# Contingency Modeling Enhancements Straw Proposal Comments

**Figure E.7 Average hourly energy from exceptional dispatches**

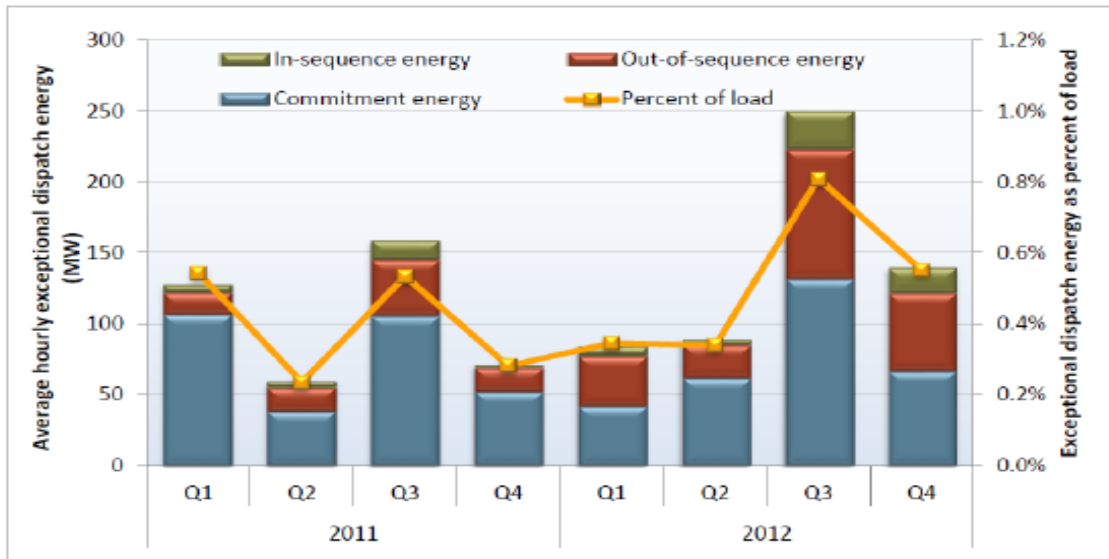
As DMM noted, the total Exceptional Dispatches (EDs) fall below 1% in all quarters in 2012, with most quarters below 0.6% (see chart below from 2012 DMM Annual Report)

Further, the EDs due to the TOP-007-WECC-1 standard only account for 40% of all EDs, as the CAISO states: The technical paper attached to the previous ISO issue paper (as well as reproduced in Figure 2 below) showed that for 2012, 21 percent to 77 percent of all exceptional dispatch volume measured in MWhs issued by month (40 percent annual) were due to the WECC SOL standard.<sup>5</sup>

<sup>4</sup> Figure E.7. Page 12. <http://www.caiso.com/Documents/2012AnnualReport-MarketIssue-Performance.pdf> shows Exceptional Dispatches (ED) peaking at 0.8% of Energy. The CAISO's proposal addresses 40% of EDs = 0.8 x 0.4 = 0.32% of Energy.

While the volume of exceptional dispatch (MWh) is small compared to the overall market, all of these manual actions are made after the IFM and have a disproportionately larger impact on the real-time market. We have also noted in Section 7.1 that exceptional dispatches related to the WECC SOL standard cost \$47 million for 2012 (Figure 3). Note that this does not take into account the price-suppressive impacts of the exceptional dispatches nor the MOC constraints.
